Airworthiness Directive

AD No.: 2015-0226R2

Revision: This AD revises EASA AD 2015-0226R1 dated 20 November 2015, the original issue of which superseded EASA AD 2015-0160 dated 4 August 2015.

ATA 25 – Equipment / Furnishings – Hoist – Test / Replacement

Figure 1

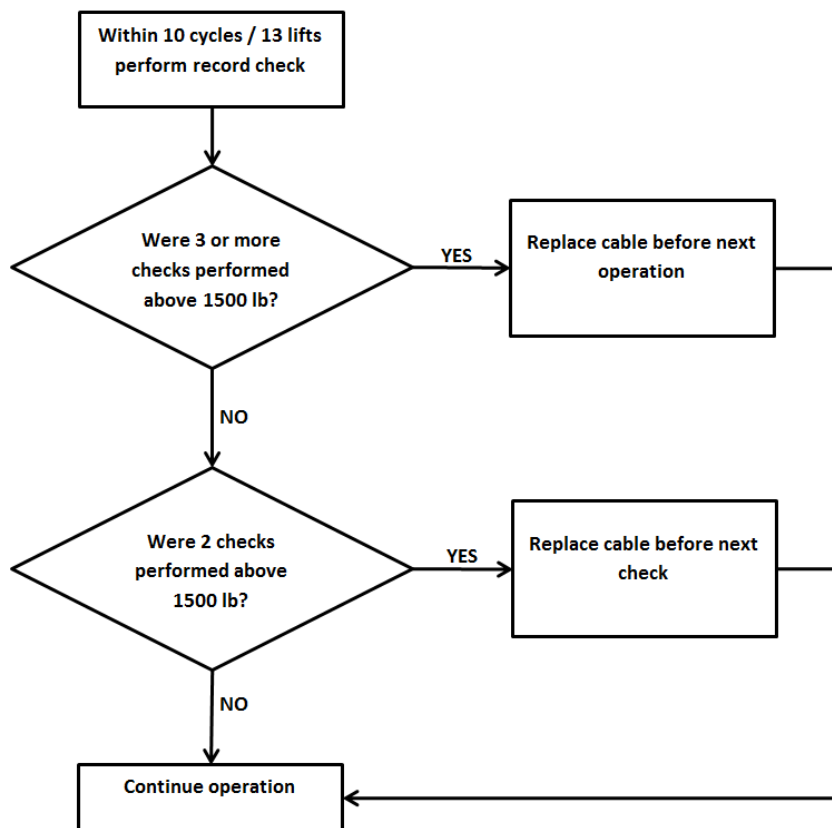
- (1) Within 10 hoist operating cycles or 13 hoist lifts (as applicable, see Note 1 of this AD) after 21 November 2015 [the effective date of the original issue of this AD], determine the P/N of the hoist installed on the helicopter and, if a Goodrich hoist is installed with a P/N listed in Table 1 of this AD, accomplish a records check to determine whether, during any previous hoist load check/test, a cable was load-tested (average of 5 pulls) at 1 500 lb [680 kg] or more. If any cable is identified to have exceeded this limit during three or more hoist load checks/tests, before next hoist operation, replace the affected cable with a serviceable cable. If any cable is identified to have exceeded this limit during two hoist load checks/tests, before the next hoist load check/test, replace the affected cable with a serviceable cable. For replacement of a cable, see figure 1 (flowchart) of this AD.
